Dublin Commuter Coalition
5 Abbeyfield
Killester
Dublin 5

ABP case ref: 314232

DART+ WEST ELECTRIFIED RAILWAY ORDER 2022

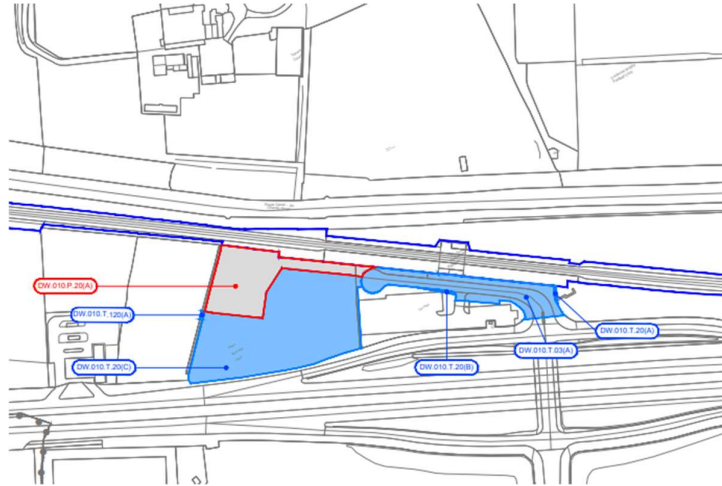
The Royal Canal acts as a physical barrier to access to a number of proposed stations. Stations that are only a short walk away in a straight line are often long walks on a dark canal. For example, Coolmine RFC is less than 250 metres away from Navan Road parkway but nearly a 2km walk. As can be seen in the drawing below, it appears this will remain the case after the completion of DART+ West.

We would like to see the Royal Canal Greenway to be completed, fully lit, secure and with increase permeability to allow greater numbers access DART sustainably.

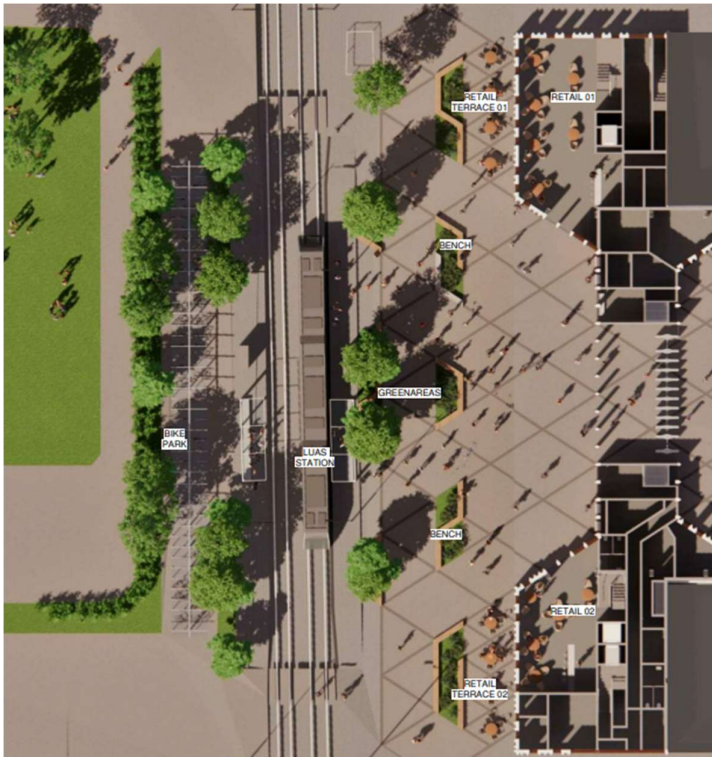
However, we are concerned at some other potential changes. For example, at Broombridge the necessary bridge heightening would appear to involve the replacement of a stone bridge in a vernacular style with a modern bridge made of an alternative material. We would object to that and argue the bridge should be rebuilt using stone maintaining the vernacular style.

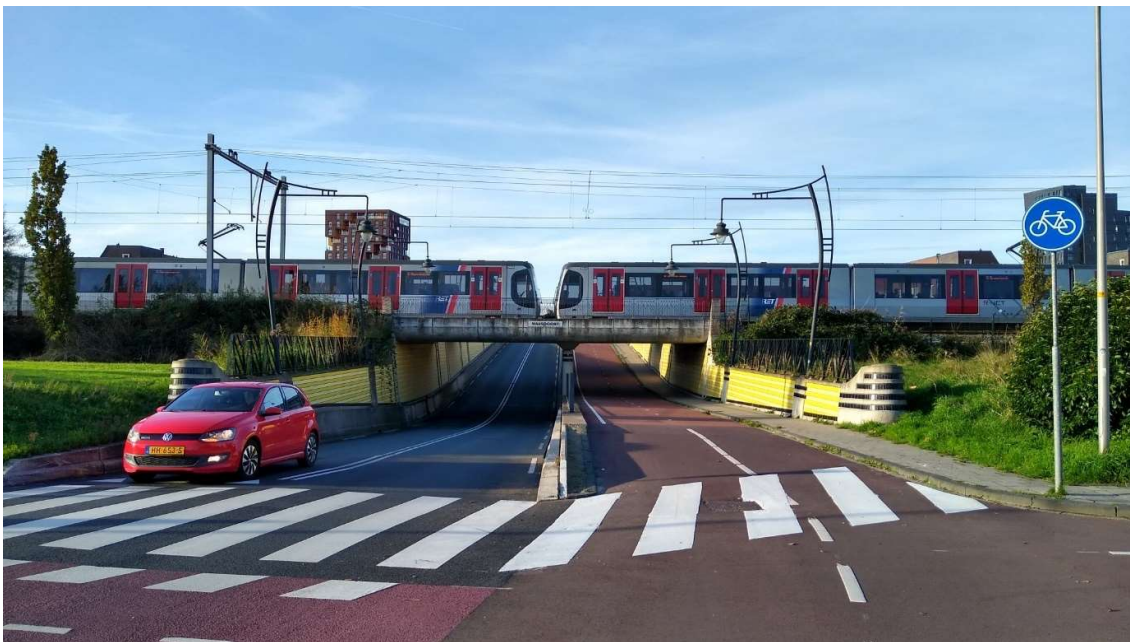
We welcome the provision of an underpass at Ashtown. For underpasses to work, it is essential that they are spacious and well-lit to provide pedestrians and cyclists with a sense of safety and security.

IE are proposing to lower both the road and pedestrian and cycling facility to the same level. This is entirely unnecessary and is against best practice across Europe. The pedestrian and cycling facilities need only be lowered as required since they do not require such a large clearance as trucks and buses on the road. This avoids creating a large unnecessary hill for pedestrians and cyclists at the underpass.

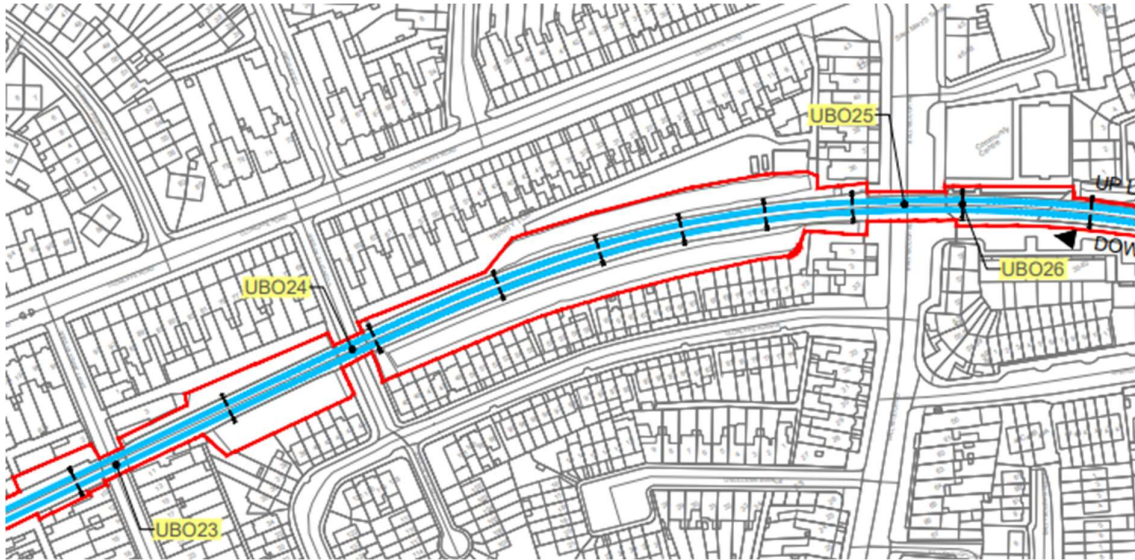
Under the proposal, there will be no station between the new Spencer Dock and Drumcondra. This is a distance of 2.5km. And there will be no station between the new Connolly & Glasnevin. This is a distance of 2.8km.

For comparison from Connolly to Tara is roughly 600m, from Tara to Pearse is roughly 550m, from Pearse to Grand Canal Dock is roughly 900m, from Grand Canal Dock to Lansdowne is roughly 850m. From Lansdowne to Connolly is roughly 2.9km not that much more the distance between Spencer Dock and Drumcondra or between Connolly & Glasnevin.

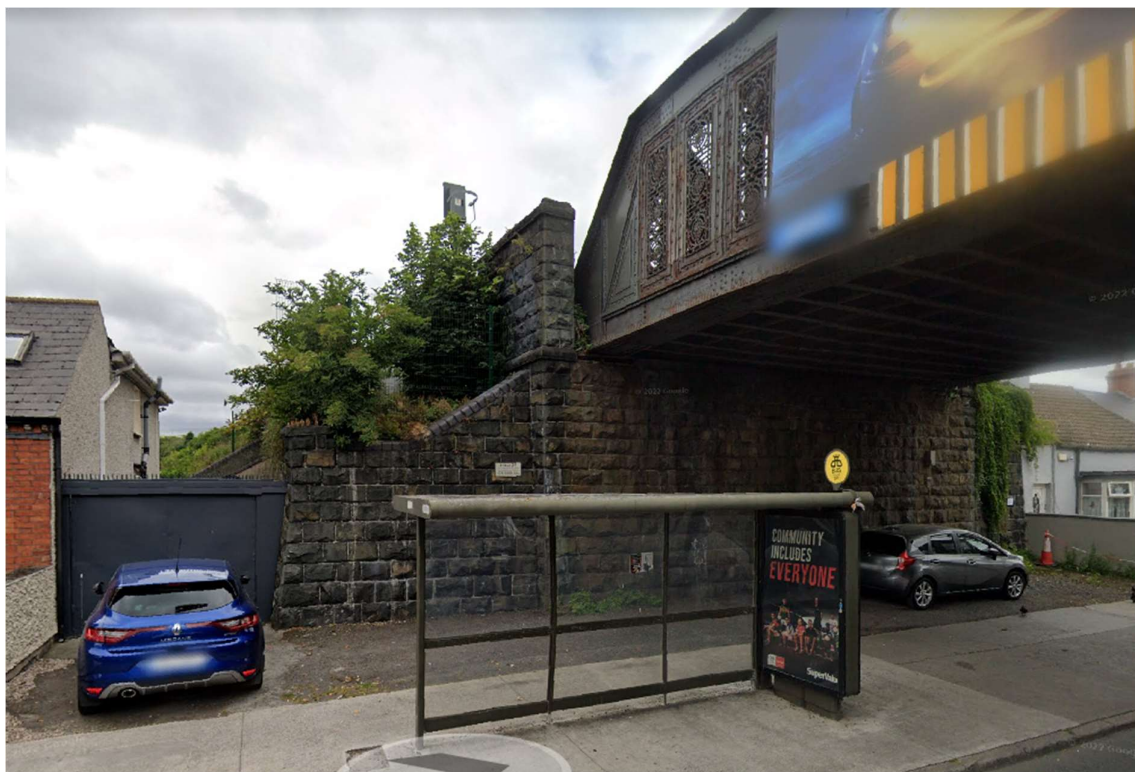
On the line between Spencer Dock and Drumcondra a new station could be created in Ballybough.

Ianród Éireann currently own substantial sidings by the rail track off Ballybough Road. (See map below.) A station could be built here.

An entrance to the station could relatively easily be created on Ballybough Road here.

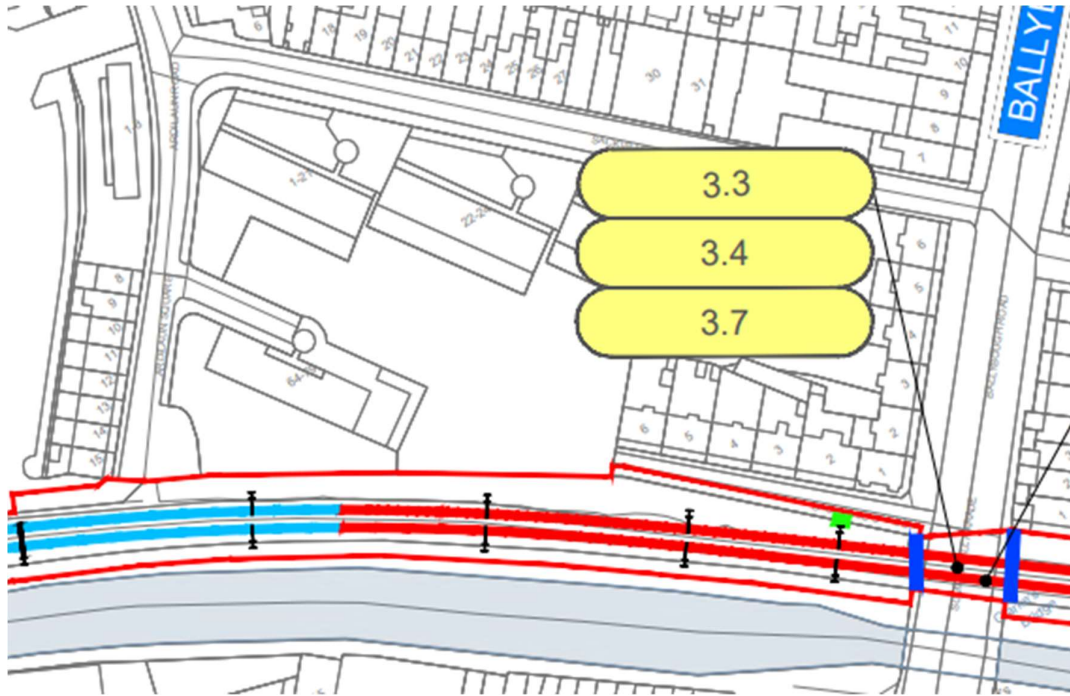
On the line between Connolly and Glasnevin, a new station could be created by Croke Park. Some land here is owned by Iarnród Éireann, but additional land would need to be purchased.

However as can be seen in the image below, there is a substantial amount of land that is available for a station here. This new station would also serve the communities of Ballybough, Fairview, North Strand, Drumcondra, Marino and Summerhill.
